APPLICATION FOR VARIANCE OR APPEAL
Jonathan Ochshorn
May 28, 2013

APPLICATION FOR VARIANCE OR APPEAL

PETITION NO:
2013-0250

PROPERTY City Town Village of Ithaca County of Tompkins
Address 943 University Avenue, Ithaca, NY 14853

Figure 15. Sibley and Milstein Halls (adapted from Cornell’s Milstein Hall web site by Jonathan Ochshorn)

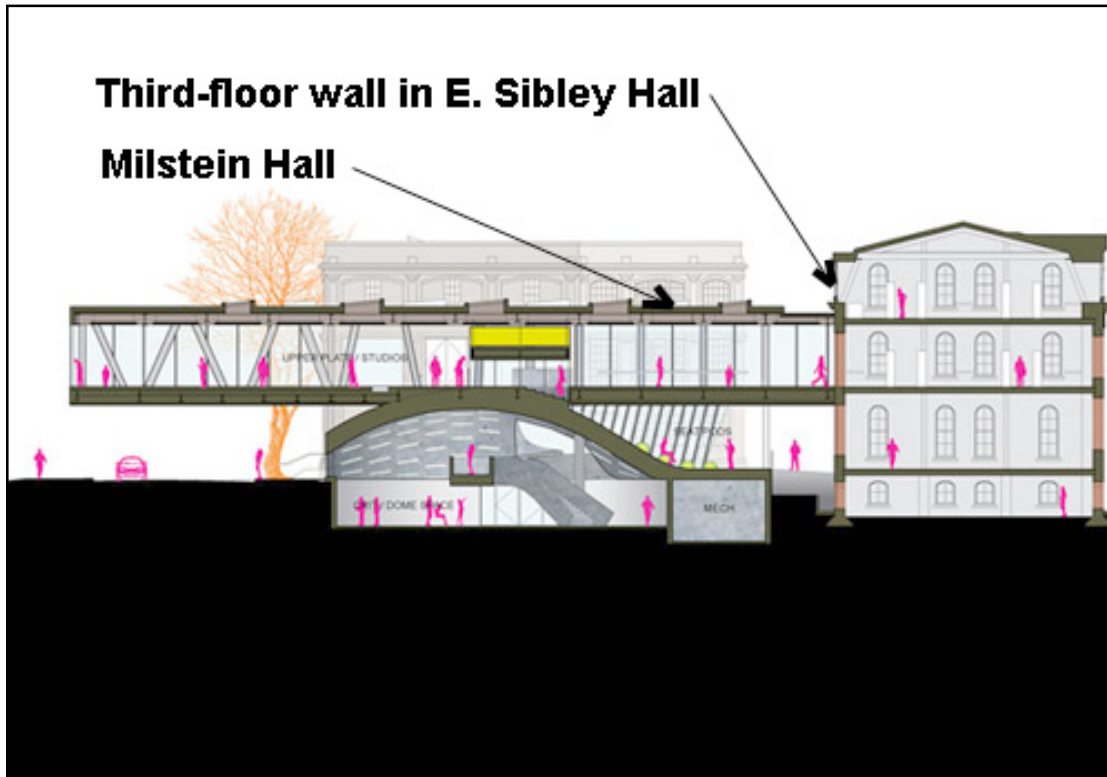
Even if one accepts the questionable premise that Milstein Hall can be designed as if it were a separate building with its own construction type, the lack of adequate fire separation distance between Milstein and Sibley Halls makes the combustible wood-framed third-floor wall of Sibley Hall noncompliant (Figure 15).

The 2002 Building Code of NYS (specifically, Section 704.10), under which Milstein Hall was permitted, requires that “opening protectives” be provided “in every opening that is less than 15 feet (4572 mm) vertically above the roof of an adjoining building or adjacent structure that is within a horizontal fire separation distance of 15 feet (4572 mm) of the wall in which the opening is located.” All of the window openings in the third floor of E. Sibley Hall that overlook Milstein Hall qualify under this section for opening protectives. The only exception to this requirement is where the roof construction below the openings has a 1-hour fire-resistance rating and its structure (i.e., the steel beams and girders supporting the roof) has a 1-hour fire-resistance rating. Milstein Hall’s roof structure has no fire-resistance rating, so the exception does not apply.

If the fire barrier is seen as replacing a fire wall that “serves as an exterior wall for a building and separates buildings having different roof levels [as is the case with the Milstein/Sibley fire barrier – see Figure 15], such wall shall terminate at a point not less than 30 inches above the lower roof level, provided the exterior wall for a height of 15 feet above the lower roof is not less than 1-hour fire-resistance-rated construction from both sides with openings protected by assemblies having a 3/4-hour fire protection rating.” (Section 705.6.1 Stepped buildings, 2002 NYS Building Code). The existing 3rd-floor exterior wall of Sibley Hall does not satisfy these requirements.

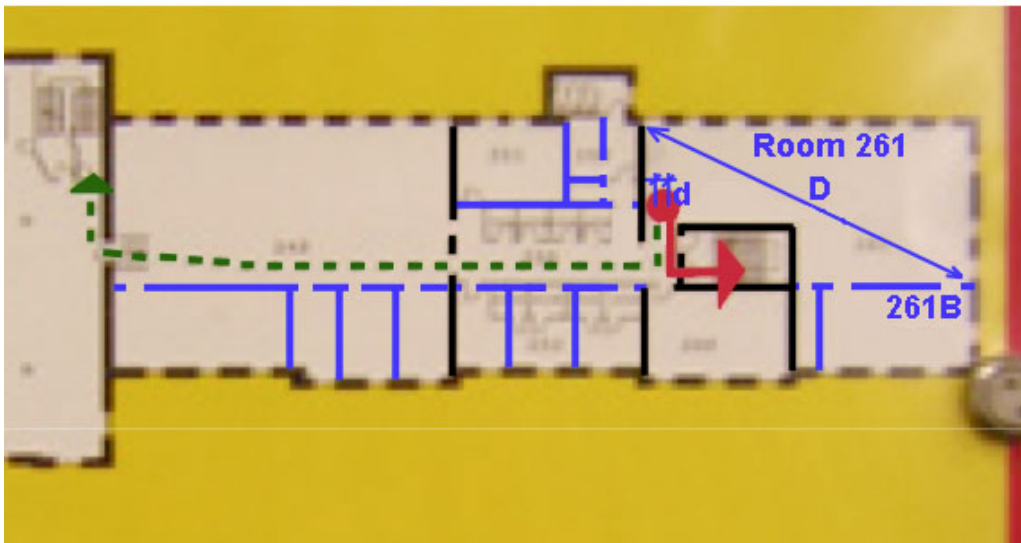
After Milstein Hall was occupied in Fall 2011, the Fine Arts Library in adjacent Sibley Hall was moved to Rand Hall and a new form of assembly occupancy was created in the spaces vacated by the library. A posted occupancy sign for one of these spaces, 261 E. Sibley Hall, allows 112 to 300 people (replaced with a sign allowing up to 240 people: see Figure 16a). As can be seen in the plan that accompanies the occupancy limits (Figure 16b, annotated in blue by Jonathan Ochshorn), there is only one exit from the space, even though its posted maximum occupancy is greater than 49 occupants.

Section 705.2 of the 2010 Existing Building Code exempts "[b]uildings constructed in conformance with the Uniform Fire Prevention and Building Code, State Building Construction Code or other codes in force before the effective date of this code." On the other hand, Section 912.1 states that "provisions of this section shall apply to buildings or portions thereof undergoing a change of occupancy classification. *This includes a change of occupancy classification within a group as well as a change of occupancy classification from one group to a different group.* Such buildings shall also comply with Sections 902 through 911" (emphasis added). Section 912.4.2, Means of egress for change of use to equal or lower hazard category, states: "When a change of occupancy classification is made to an equal or lesser hazard category (higher number) as shown in Table 912.4, existing elements of the means of egress shall comply with the requirements of Section 805 for the new occupancy classification." Section 805.1 states: "The means of egress shall comply with the requirements of Section 705..." Finally, Section 705.4.1.1, Occupant load and travel distance, states: "In any work area, all rooms and spaces having an occupant load greater than 50 or in which the travel distance to an exit exceeds 75 feet (22 860 mm) *shall have a minimum of two egress doorways*" (emphasis added).
